ROCHESTER GAS AND ELECTRIC CORPORATION

R.E. GINNA NUCLEAR POWER PLANT

Revision 12 to:-

Quality Assurance Program For
Station Operation

FIGURE 2-1

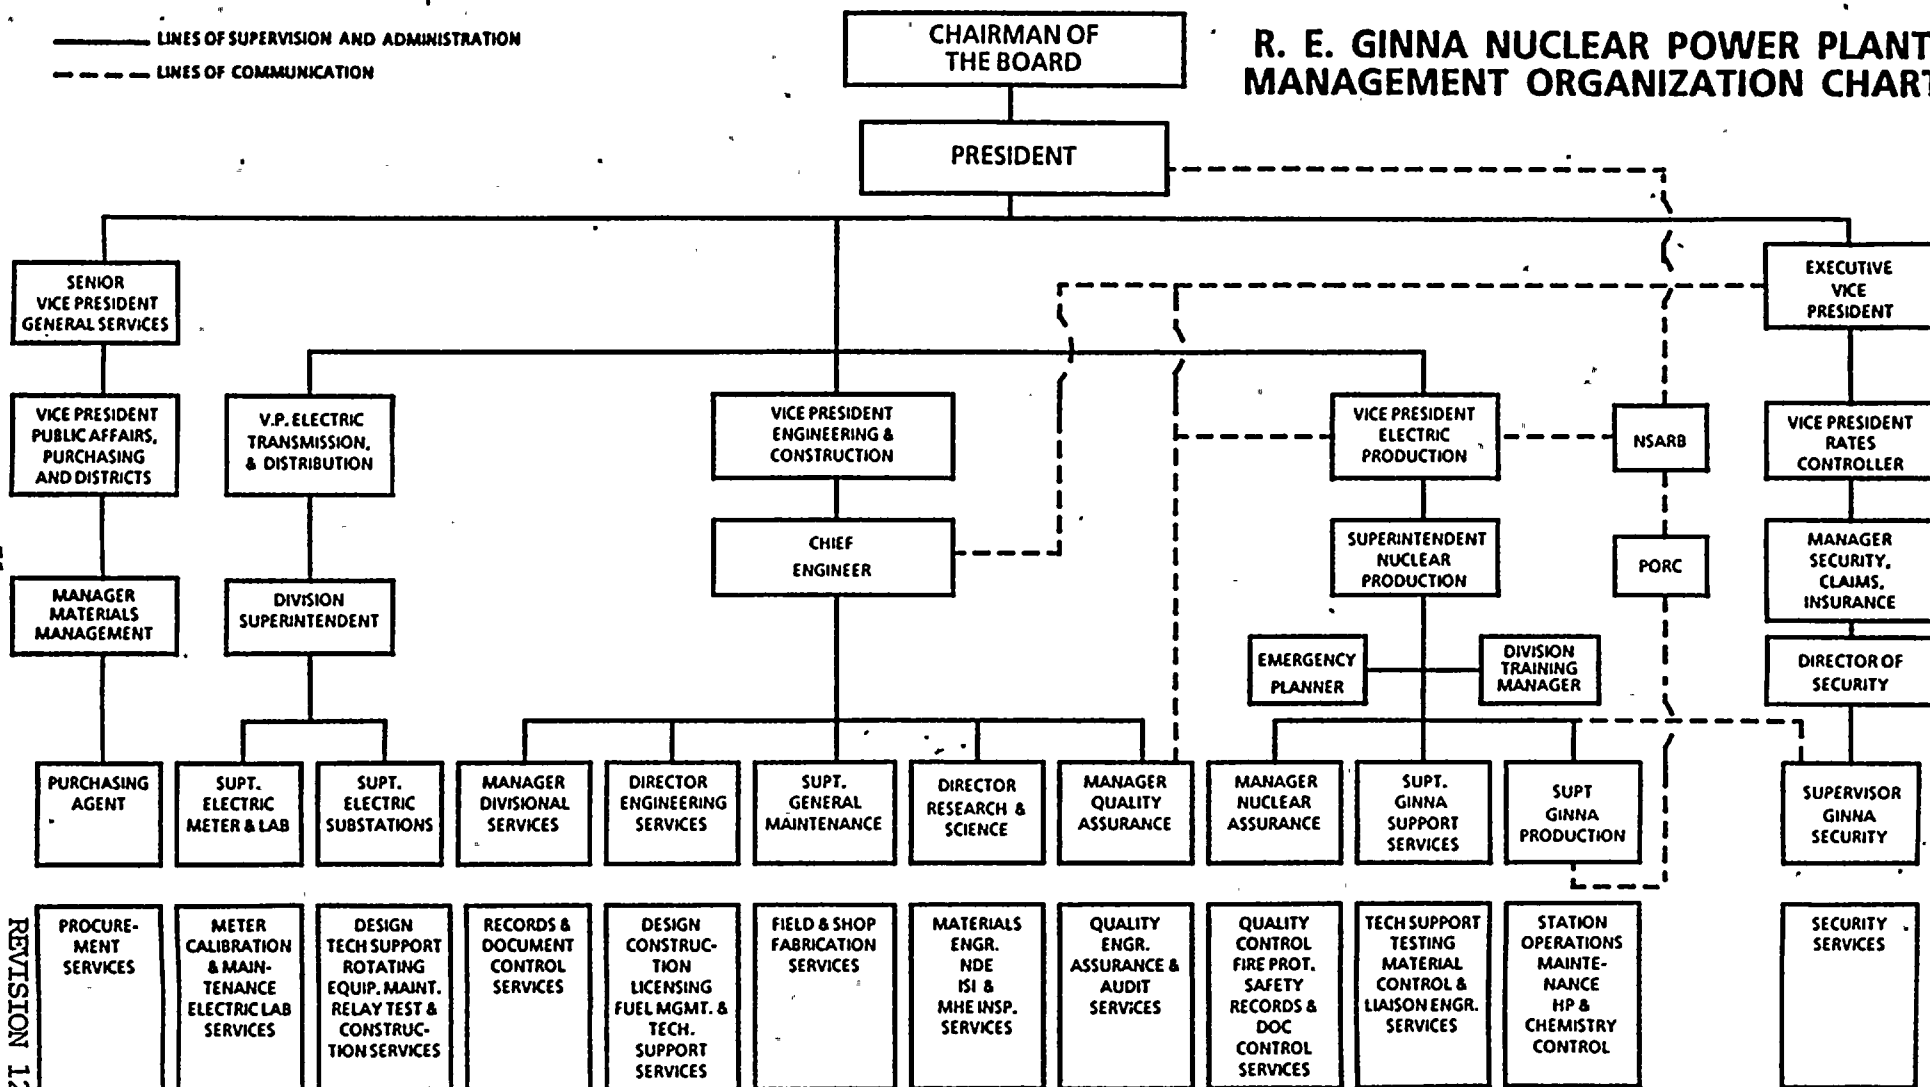
Revision 12 incorporates recent changes in the management Engineering, Ginna and General Maintenance organizations depicted in Figures 2-1, 2-3, 2-4 and 2-5, respectively. Figure 2-5 now reflects the organization of the Engineering Division which includes the departments of General Maintenance and Engineering previously depicted in Figures 2-4 and 2-5 respectively. Figure 2-4 now illustrates the Electric Transmission and Distribution organization. Additionally, minor clarifications have been made to the sections associated with supplier selection (Section 7), Quality Assurance Manager experience and responsibility (Section 2), and clarification of those reports forwarded to Quality Assurance and management described in Sections 15 and 16. The Table 1 listing of the various implementing procedures has also been revised to reflect the two added departments and related shift in responsibilities.
